Proposed Plugging Procedures

Byers 59 #2

Element Petroleum Operating, LLC LC0663659; BYERS 59 #2 1980' FSL & 1980' FWL, Sec. 30, T09S-R38E Lea County, New Mexico

RE: Plugging and Abandonment Requirements, Condition of Approval

WELL - BORE DIAGRAM

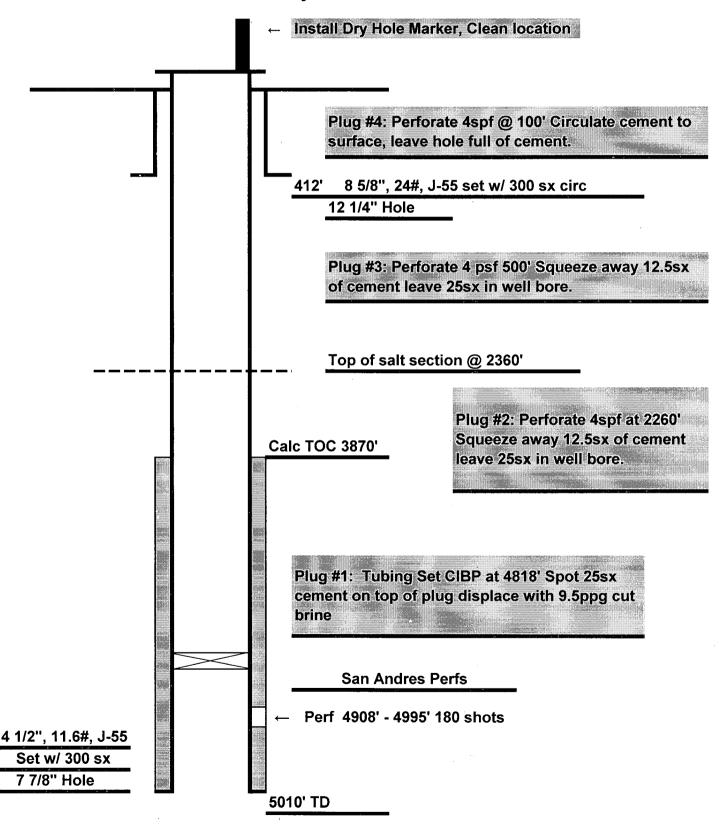
- 1. OK
- 2. Change. Perforate @ 2977' (Base of Salt), squeeze with adequate cmt to fill 120' in/out of 4-1/2" csg. If unable to pump into perfs, spot a balanced plug from 3027'-2907' (25 sx minimum). WOC and tag no lower than 2907'.
- 2.a. Add. Perforate @ 2478' (Top of Salt), squeeze with adequate cmt to fill 120' in/out of 4-1/2" csg. If unable to pump into perfs, spot a balanced plug from 2528'-2408' (25 sx minimum). WOC and tag no lower than 2408'.
- 3. Change. Perforate @ 462' (8-5/8" csg shoe), squeeze with adequate cmt to fill 100' (50' in/out of shoe. If unable to pump into perfs, spot a balanced plug from 502'-362' (25 sx minimum). WOC and tag no lower than 362.
- 4. OK
